APPLICATION NO.	FILING DATE	FIRST NAMED INVENTOR	ATTORNEY DOCKET NO.	CONFIRMATION NO.
10/702,178	11/05/2003	Jack V. Henderson	19350-095172	7542
7590 03/23/2006			EXAMINER	
Mr. Robin W. Asher Clark Hill, P.L.C. Suite 3500 500 Woodward Avenue Detroit, MI 48226-3435			ENGLISH, EVAN JAMES	
			ART UNIT	PAPER NUMBER
			3652	
DATE MAILED: 03/23/2006

Office Action Summary

DETAILED ACTION

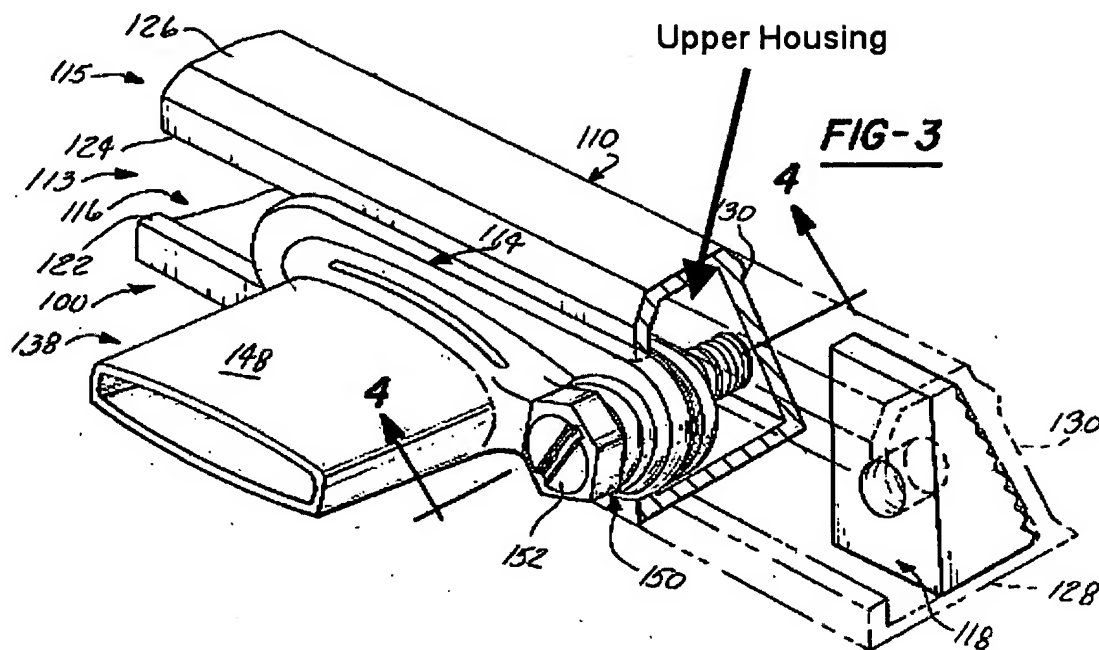
With respect to claim 14, Mabry does not disclose an upper housing disposed above a channel and extending along a portion thereof.

Kowalski et al. discloses an upper housing disposed above a channel and extending along a portion thereof as shown below.

It would be obvious to one having ordinary skill in the art at the time the invention was made to include the upper housing on the channel as taught by Kowalski et al. to the roof rack assembly of Mabry in order to prevent the pin from being easily removable from the channel by allowing it to extend upwardly inside the channel.
